Final Set, Jefferson Village Phase II  
(Bulletin 6)

JEFFERSON VILLAGE

TYPICAL PAVEMENT CROSS SECTIONS

HOR. SCALE: NO SCALE  
VER. SCALE: NO SCALE  
DATE: 3-27-00  
JOB NO.: DE99011  
FILE NO.: DE9911X1  
SHEET NO.: P-0.2

MONTCLAIR AVE. STA. 240+00 TO STA.250+50  
 PAVING - PLAN & PROFILE

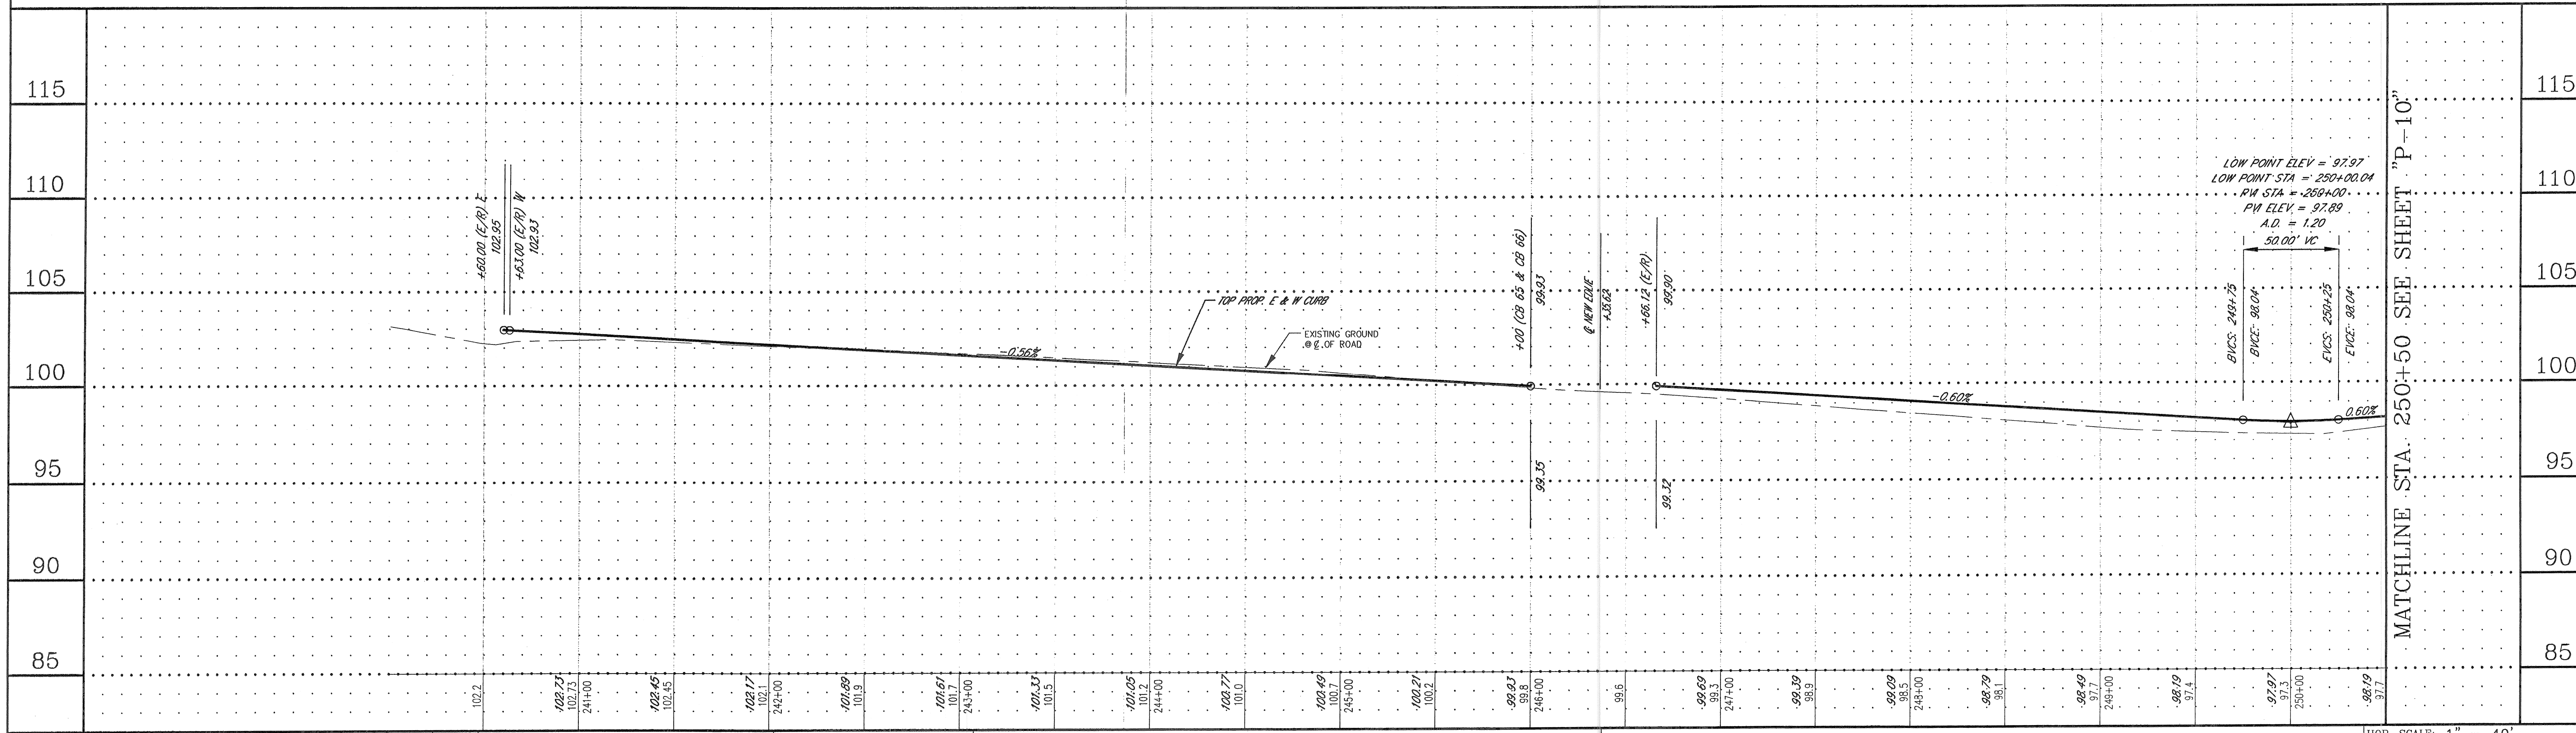
**NOTE:**  
 THE TYPE OF CURB WAS CHANGED FROM 7" HIGH STRAIGHT FACE TO 4" HIGH ROLLED CURB AFTER THE PREPARATION OF THE PAVING PLANS AND PROFILES (EXCEPTING FOR FREUD, MARQUETTE AND NEW STREET BETWEEN BENAIEU AND ST. JEAN). THE PAVEMENT ELEVATIONS AS SHOWN ON THE INTERSECTION DETAILS SHEETS SHALL BE MAINTAINED. ONLY THE TOP OF CURB ELEVATIONS SHALL BE DROPPED BY 0.25" (3"). THIS SHALL BE ACHIEVED BY SUBTRACTING 0.25" (3") FROM THE TOP OF CURB ELEVATIONS SHOWN ON THE PROFILES.

MONTCLAIR AVE. STA. 250+50 TO STA. 262+50  
 PAVING - PLAN & PROFILE

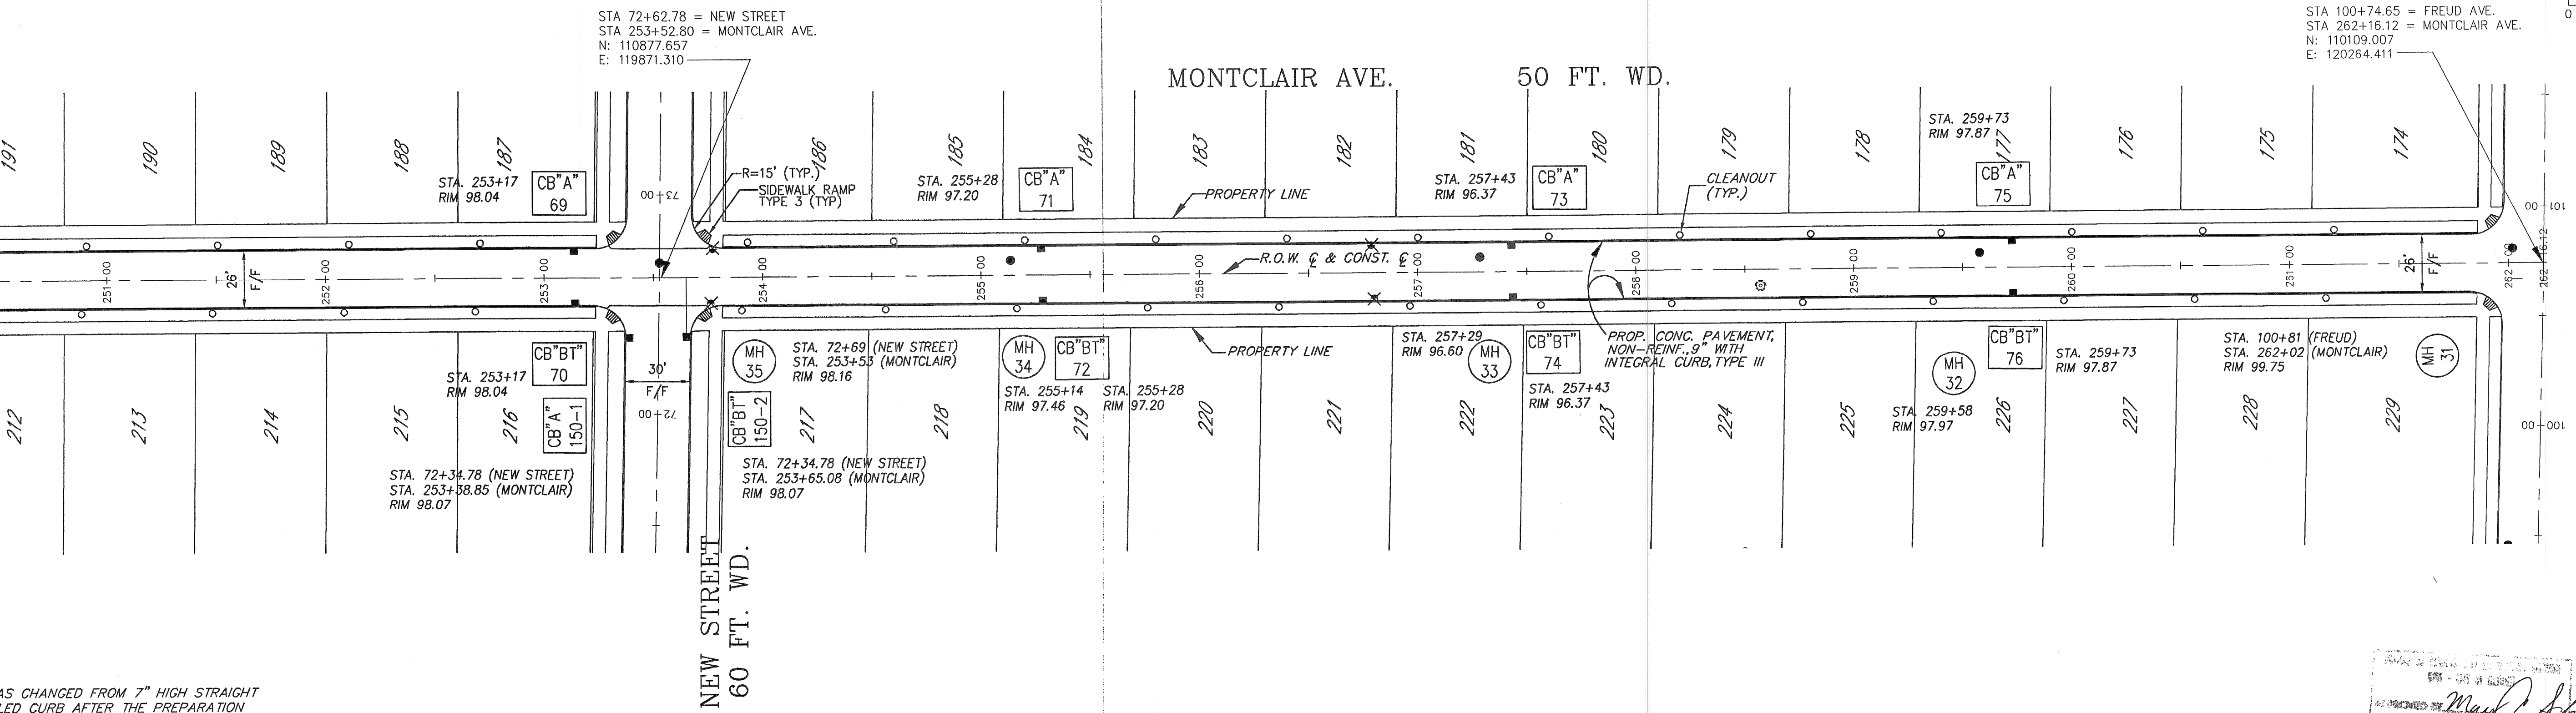
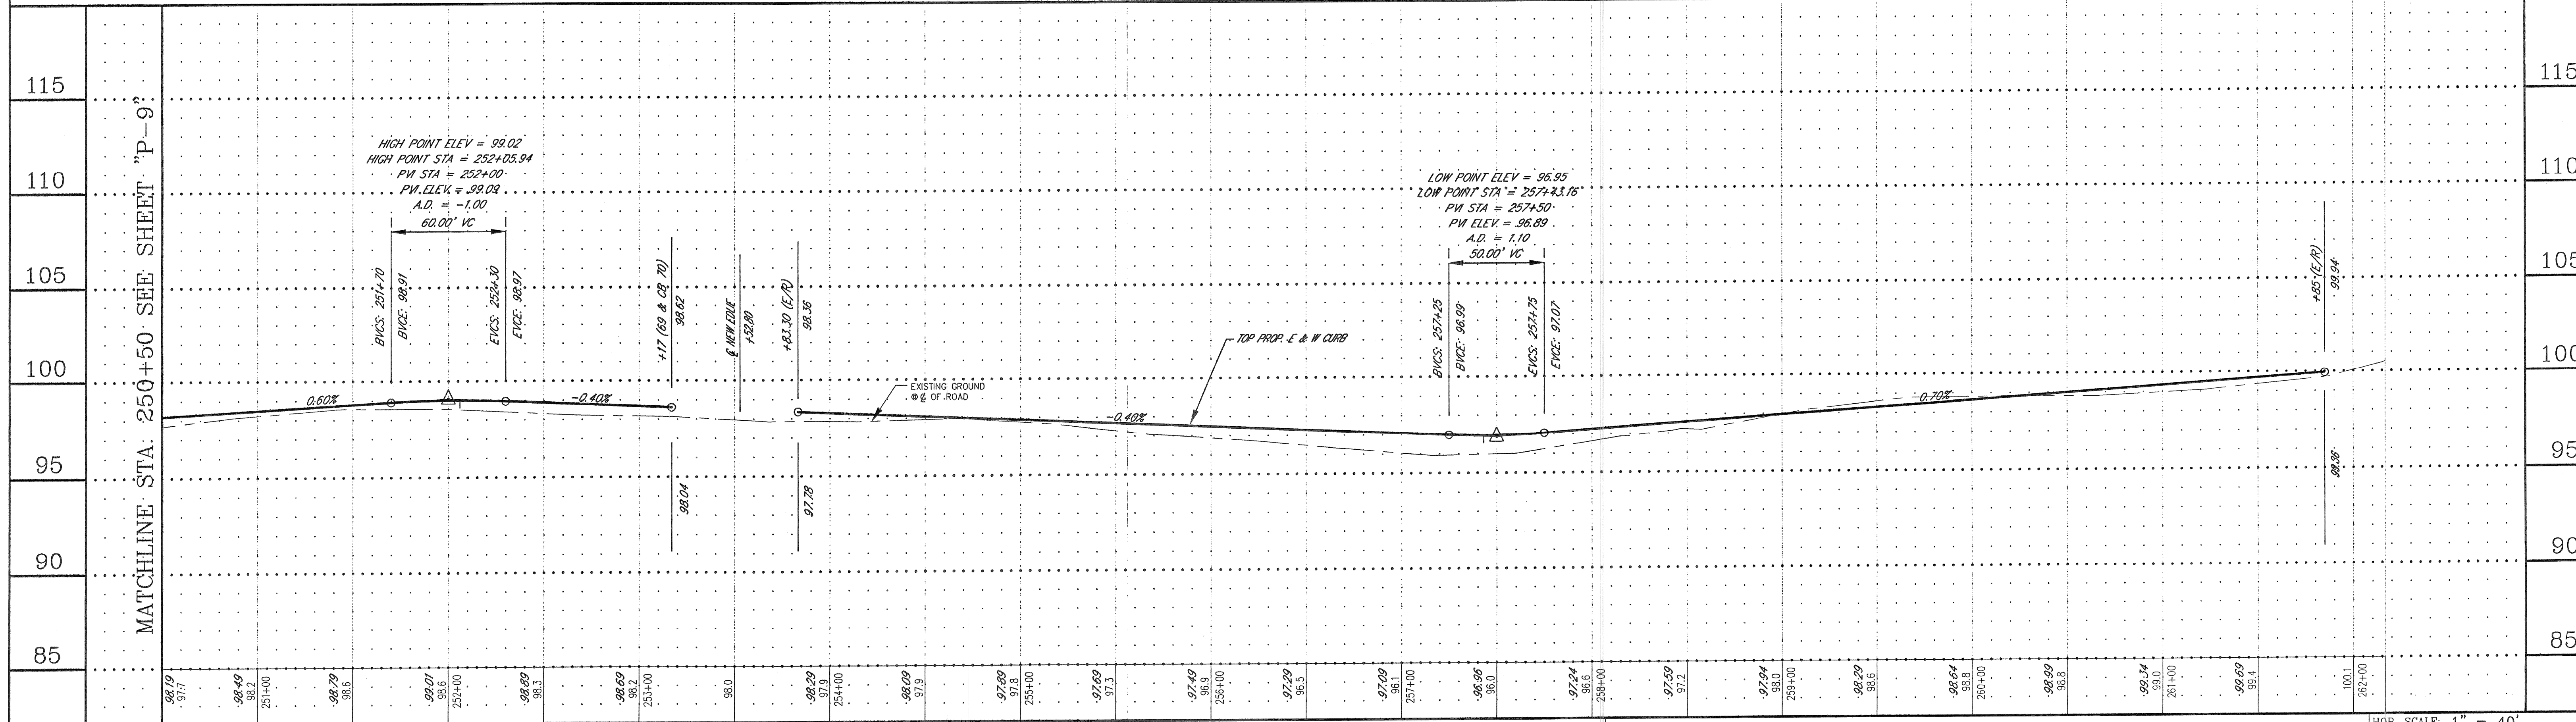
**NOTE:**  
 THE TYPE OF CURB WAS CHANGED FROM 7" HIGH STRAIGHT FACE TO 4" HIGH ROLLED CURB AFTER THE PREPARATION OF THE PAVING PLANS AND PROFILES (EXCEPTING FOR FREUD, MARQUETTE AND NEW STREET BETWEEN BENITEAU AND ST. JEAN). THE PAVEMENT ELEVATIONS AS SHOWN ON THE INTERSECTION DETAILS SHEETS SHALL BE MAINTAINED. ONLY THE TOP OF CURB ELEVATIONS SHALL BE DROPPED BY 0.25' (3"), THIS SHALL BE ACHIEVED BY SUBTRACTING 0.25' (3") FROM THE TOP OF CURB ELEVATIONS SHOWN ON THE PROFILES.

LEMAY AVE. STA. 270+00 TO STA. 278+00  
 PAVING - PLAN & PROFILE

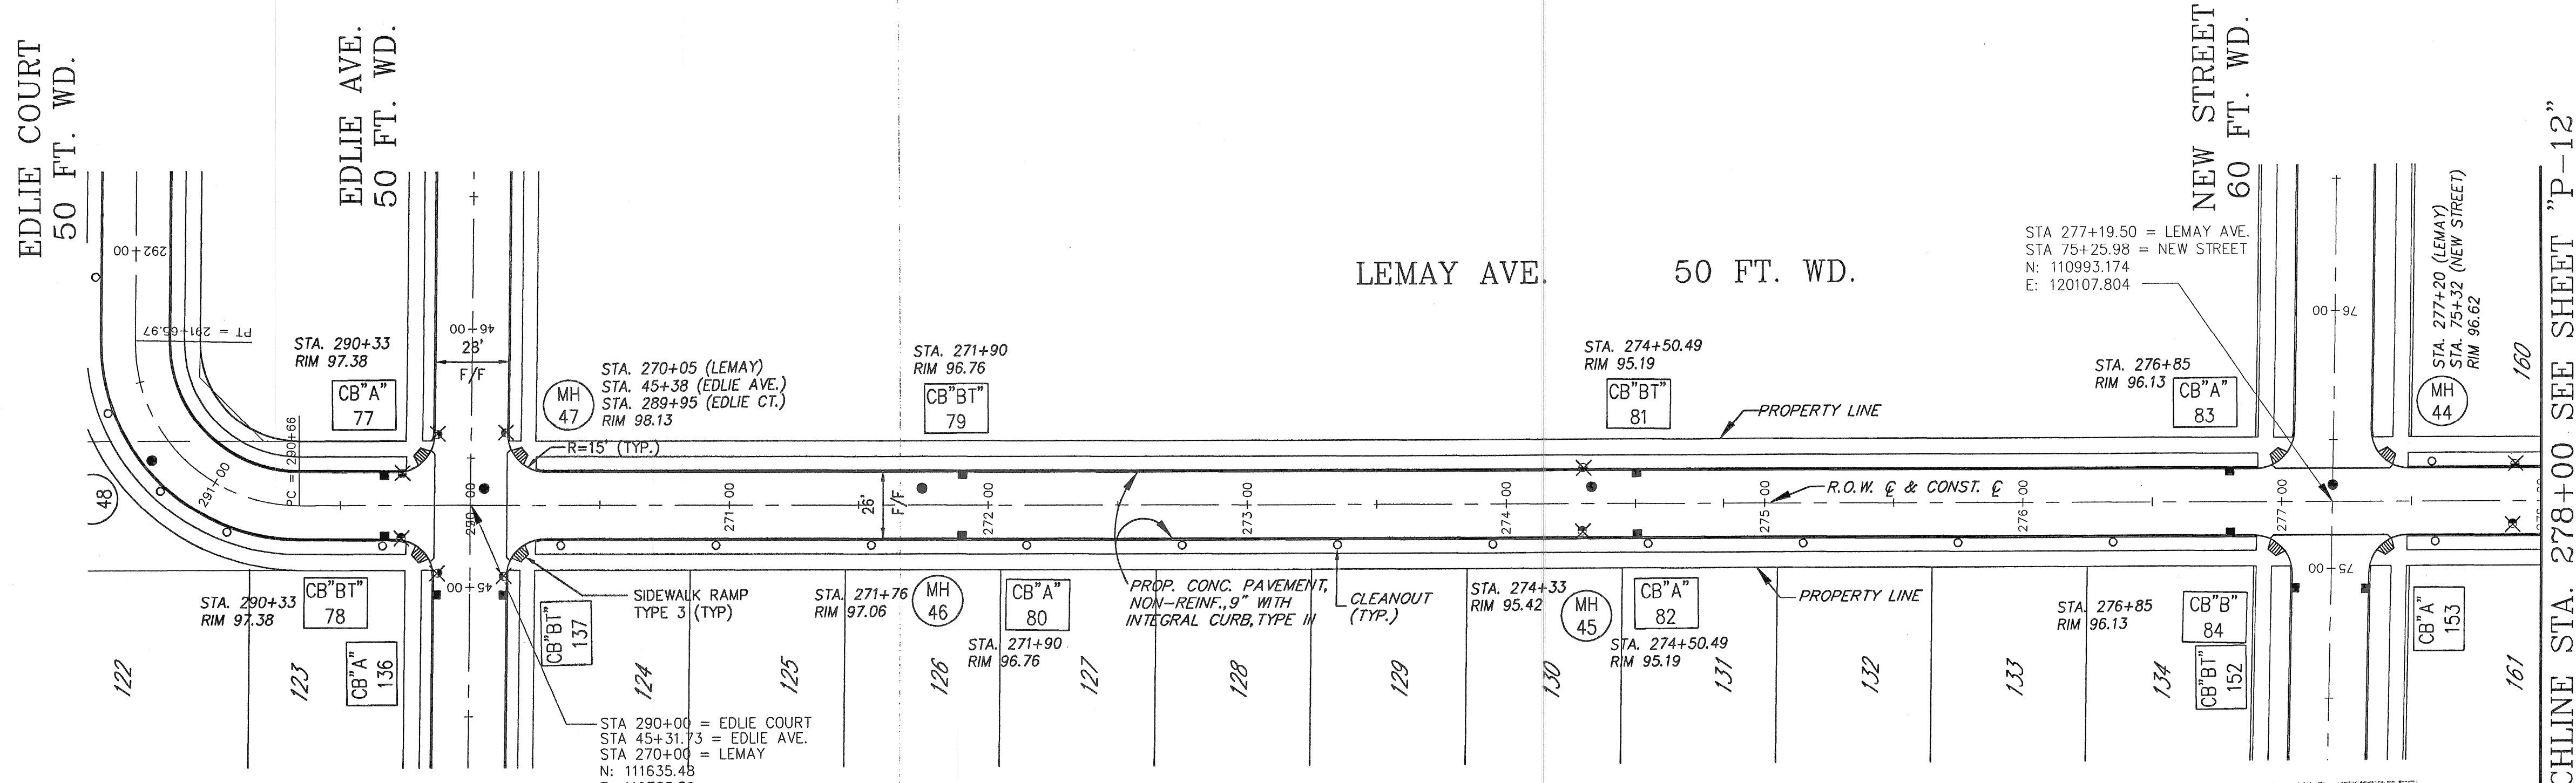
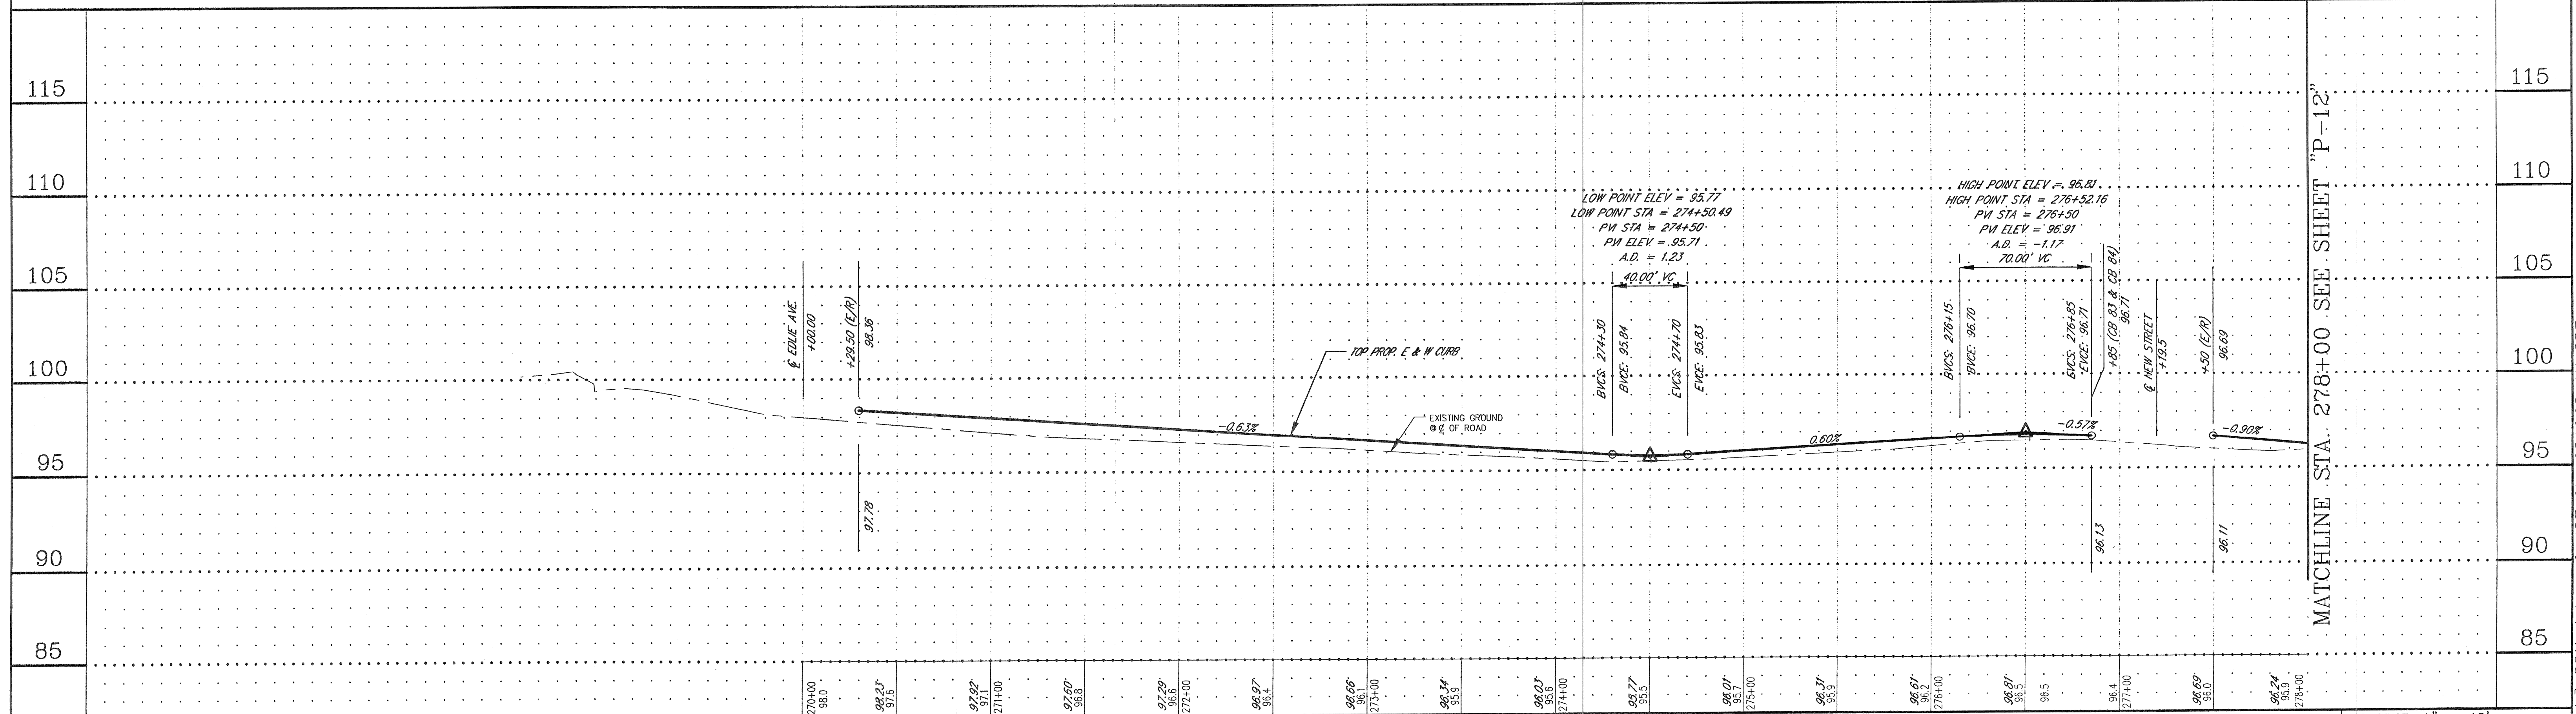
**NOTE:**  
 THE TYPE OF CURB WAS CHANGED FROM 7" HIGH STRAIGHT FACE TO 4" HIGH ROLLED CURB AFTER THE PREPARATION OF THE PAVING PLANS AND PROFILES (EXCEPTING FOR FREUD, MARQUETTE AND NEW STREET BETWEEN BENITEAU AND ST. JEAN). THE PAVEMENT ELEVATIONS AS SHOWN ON THE INTERSECTION DETAILS SHEETS SHALL BE MAINTAINED. ONLY THE TOP OF CURB ELEVATIONS SHALL BE DROPPED BY 0.25' (3"). THIS SHALL BE ACHIEVED BY SUBTRACTING 0.25' (3") FROM THE TOP OF CURB ELEVATIONS SHOWN ON THE PROFILES.
